STE PLAN REVIEW

LOT NO 68 REGISTERED PLAN 65M - 4500

KLEINBURG GLEN VAUGHAN, ON

SITE PLAN

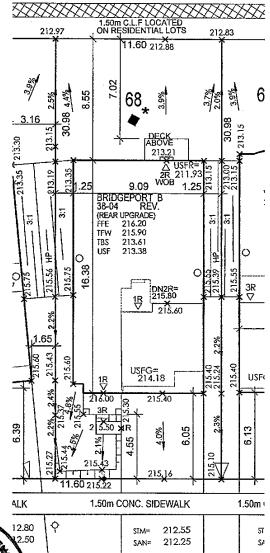
THE PROPOSED LOT GRADING AND DRAINAGE IS APPROVED AS BEING IN CONFORMITY WITH THE OVERALL APPROVED GRADING PLANS FOR THE SUBDIVISION.
